ADDENDUM NO. 1 TO PLANS AND SPECIFICATIONS

Project: Orange Grove Vol. Fire Station # 2 Bldg. Addition (6801 Rocky Ridge Road)
Date: Friday, March 6, 2026
By: Jorge Rodriguez, AIA 
Bid Date: March 12, 2026
Bid Time: 2:00 P.M. EST
Bid Location: Orange Grove Fire Station # 1 (6800 Orange Grove Road, Hillsborough, NC 27278)

SHEET NO. P-1

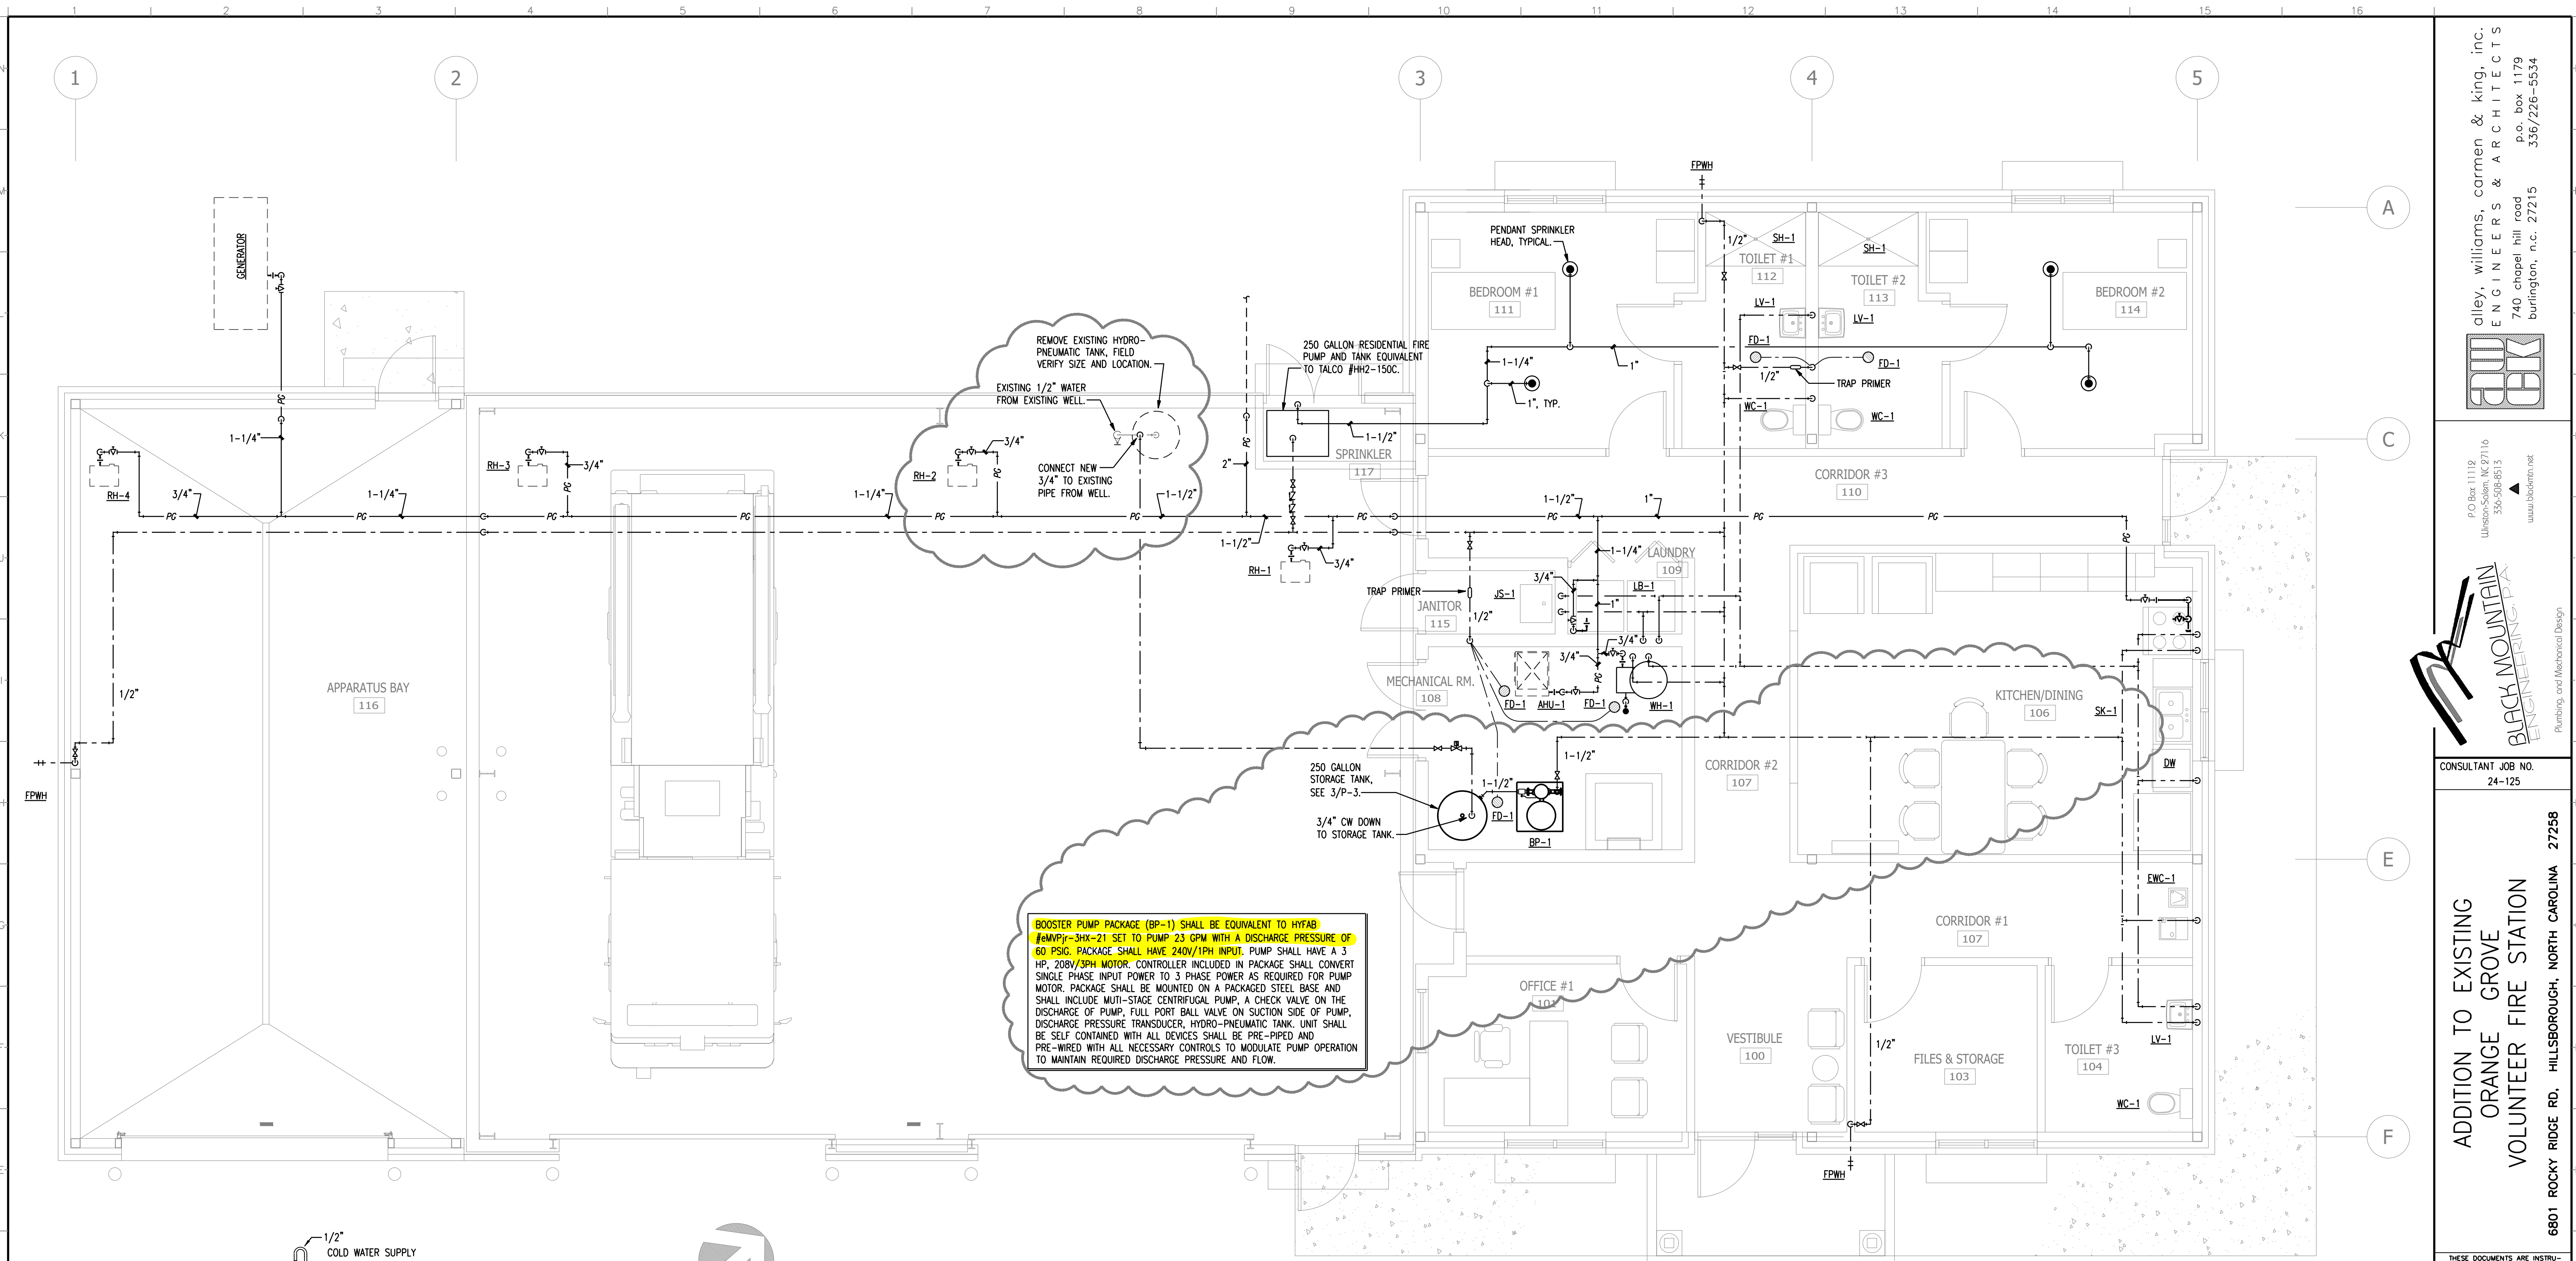
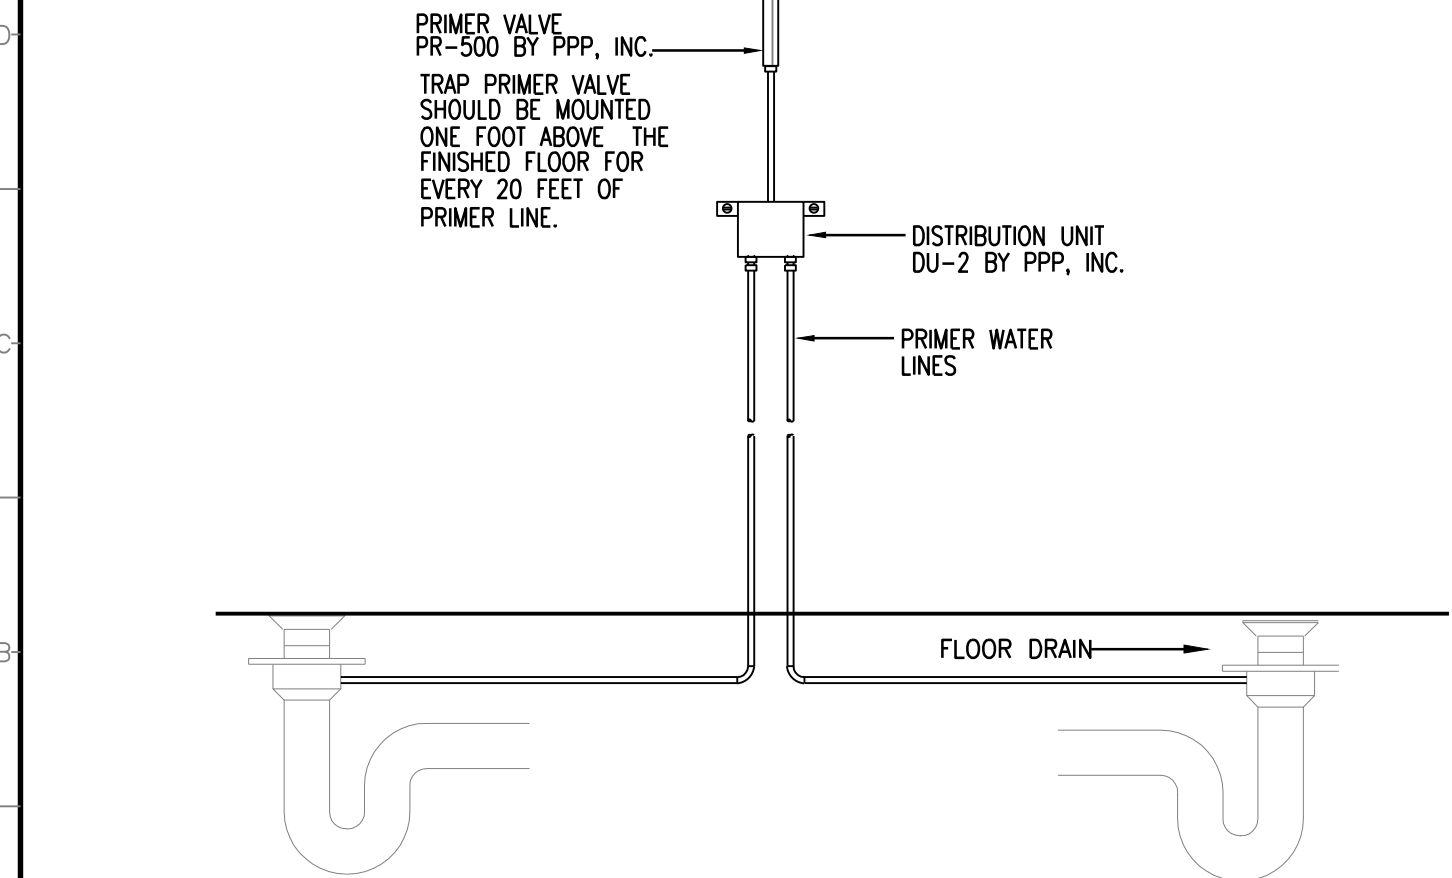
- 1. Sheet P-1:**
 - a. Remove existing hydro pneumatic tank on well system (located in apparatus bay). Connect new water line to existing water line where it enters the building.
 - b. Replace booster pump and new large hydro-pneumatic tank with packaged booster system which includes booster pump and hydro-pneumatic tank, BP-1 (in Mechanical Room).
 - c. Replace pressure rated steel storage tank with plastic, vented, non-rated storage tank. Provide storage tank with level controller and solenoid valve. Interlock level controller with well pump control. 1 (in Mechanical Room).

BOOSTER PUMP PACKAGE (BP-1) SHALL BE EQUIVALENT TO HYFAB #6MPP-3HX-21 SET TO PUMP 23 GPM WITH A DISCHARGE PRESSURE OF 60 PSIG. PACKAGE SHALL HAVE 240V/1PH INPUT. PUMP SHALL HAVE A 3 HP, 208V/3PH MOTOR. CONTROLLER INCLUDED IN PACKAGE SHALL CONVERT SINGLE PHASE INPUT POWER TO 3 PHASE POWER AS REQUIRED FOR PUMP MOTOR. PACKAGE SHALL BE MOUNTED ON A PACKAGED STEEL BASE AND SHALL INCLUDE MULTI-STAGE CENTRIFUGAL PUMP, A CHECK VALVE ON THE DISCHARGE OF PUMP, FULL PORT BALL VALVE ON SUCTION SIDE OF PUMP, DISCHARGE PRESSURE TRANSDUCER, HYDRO-PNEUMATIC TANK. UNIT SHALL BE SELF CONTAINED WITH ALL DEVICES SHALL BE PRE-PIPED AND PRE-WIRED WITH ALL NECESSARY CONTROLS TO MODULATE PUMP OPERATION TO MAINTAIN REQUIRED DISCHARGE PRESSURE AND FLOW.

3 WATER STORAGE TANK DETAIL

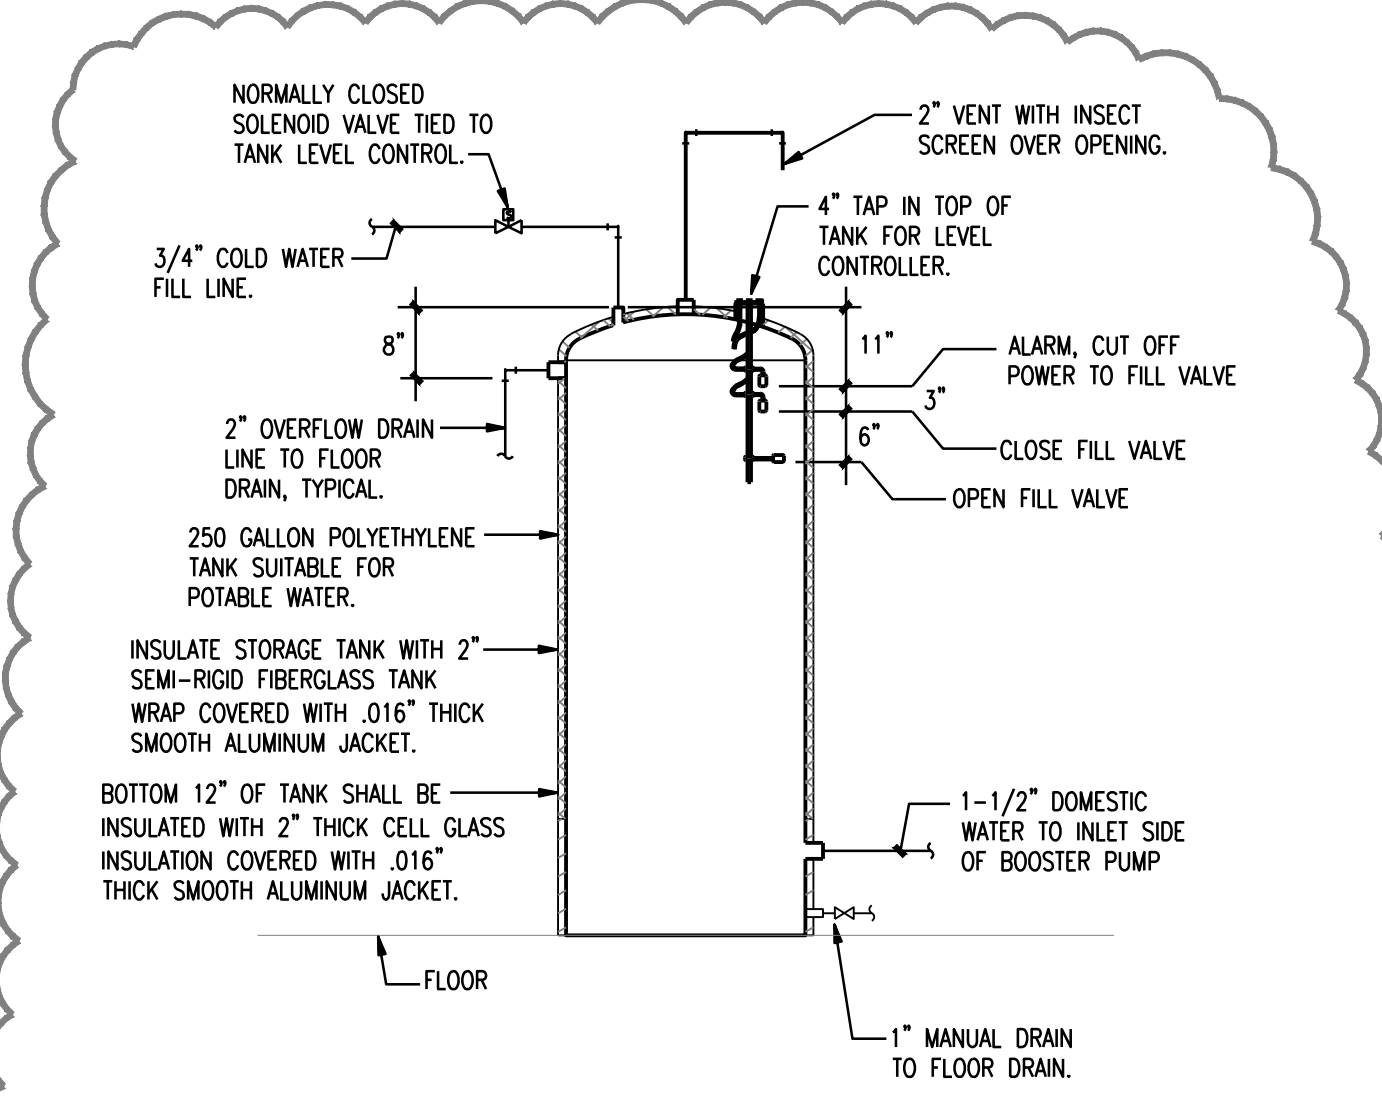
- 2. Sheet P-3:**
 - a. New Water Storage Tank Detail # 3 / P-3.

1 POWER PLAN
E3 SCALE: 3/16" = 1'-0"

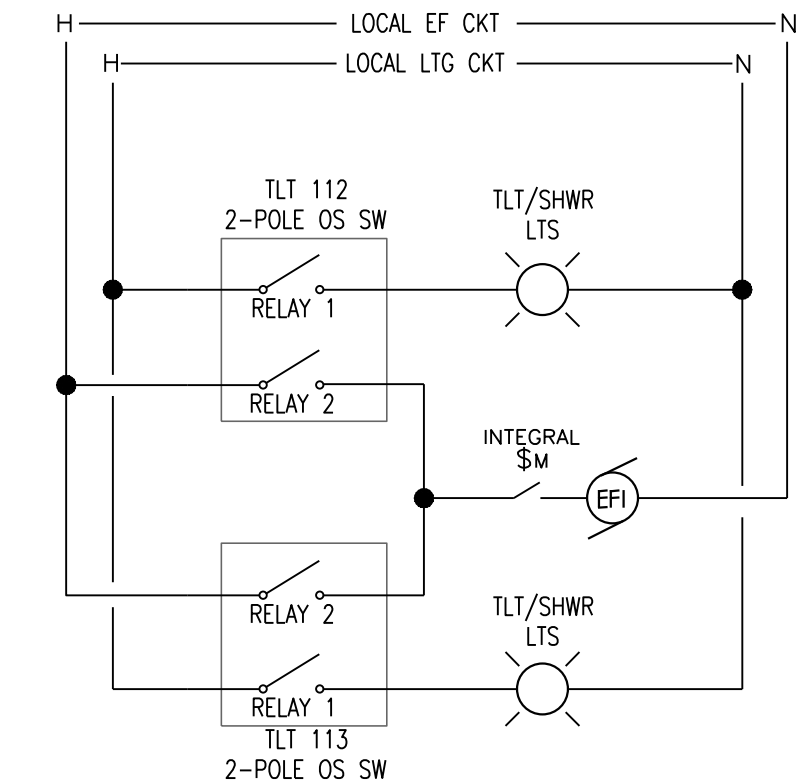
- 3. Sheet E-3:**
 - a. Provide 120 V., 30A rated, 1P toggle switch for Booster Pump.

- PROVIDE 120V, 20A RATED, 1P TOGGLE SWITCH FOR AHU1 & 120V, 30A RATED, 1P TOGGLE SWITCH FOR BOOSTER PUMP. CIRCUIT AS SHOWN & EXTEND TO EQUIPMENT.
 - PROVIDE GFI CB FOR (LP) RANGE. (BOD: 120V, 15A). COORDINATE LOCATION W/ MANUF. INSTALLATION INSTRUCTIONS.
